Service Bulletin

SB 80-1
11-29-79

SUBJECT: WINDSHIELD WIPER
VEHICLES: DINO 246GT

REISSUE OF TECHNICAL BULLETIN NO. 207, DATED 11/30/72

Make sure (see illustration)

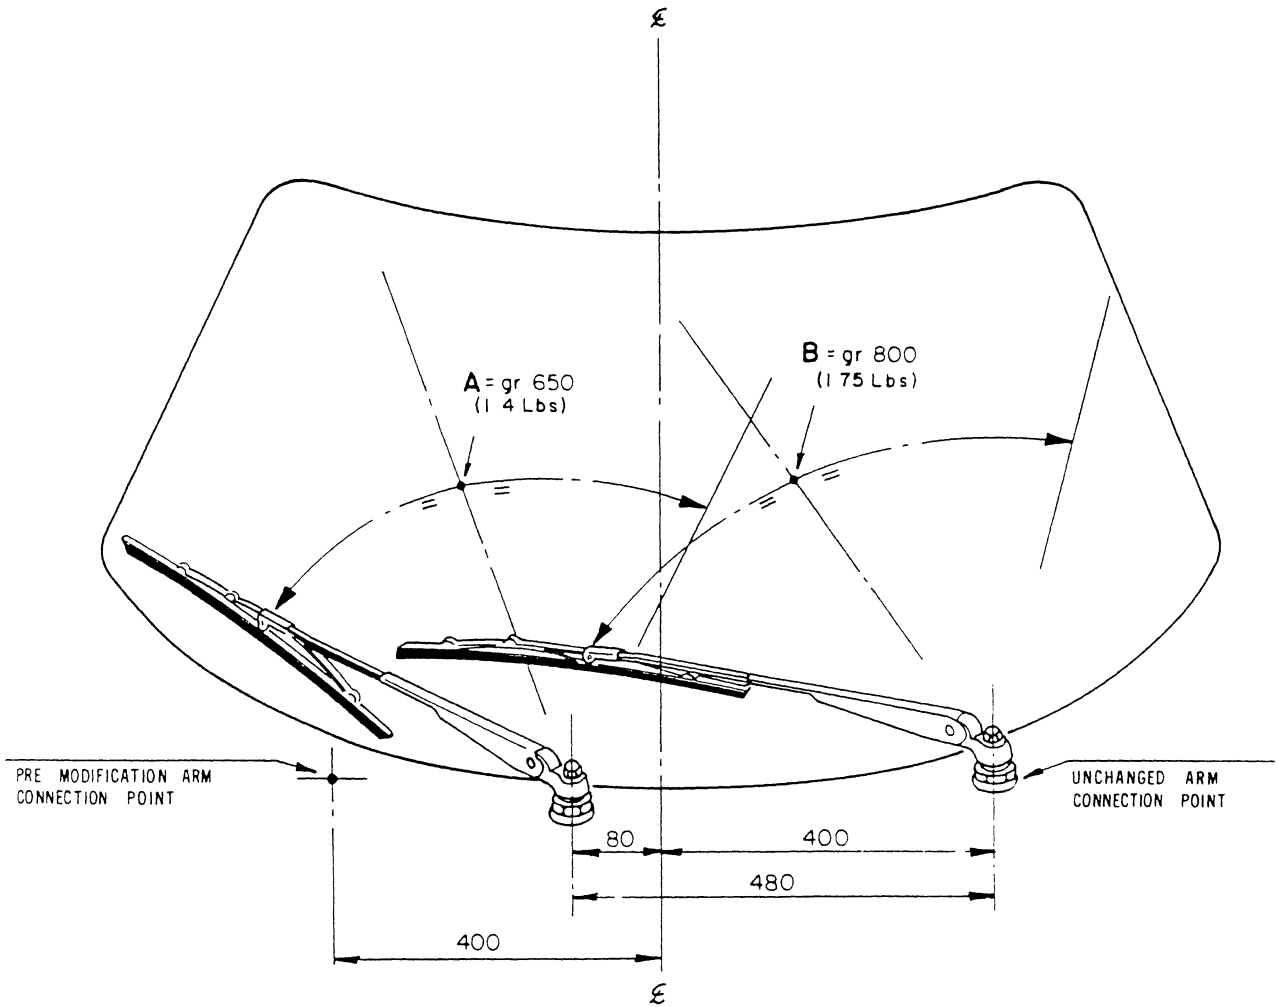
Due to the installation of a modified windshield wiper system, it is necessary to carefully check the load of the wiper arms to ensure proper wiper operation.

- The wiper motor assembly is a Marelli TGE130D
- The driver side wiper arm
 - is 16" (406mm) in length
 - has a .3504" (8.9mm) blade
 - arm load of 800 gr. (1.75 lbs), measured without wiper blade
- The passenger side wiper arm
 - is 17" (431mm) in length
 - has a .3504" (8.9mm) blade
 - arm load of 650 gr. (1.4 lbs) measured without wiper blade
- Both wiper blades are 18" (457mm) in length

THE ARMS LOAD WITHOUT WIPER BLADES AND MEASURED ON THE "A" AND "B" POINTS, SHOULD BE OF GR 650 AND GR 800 RESPECTIVELY
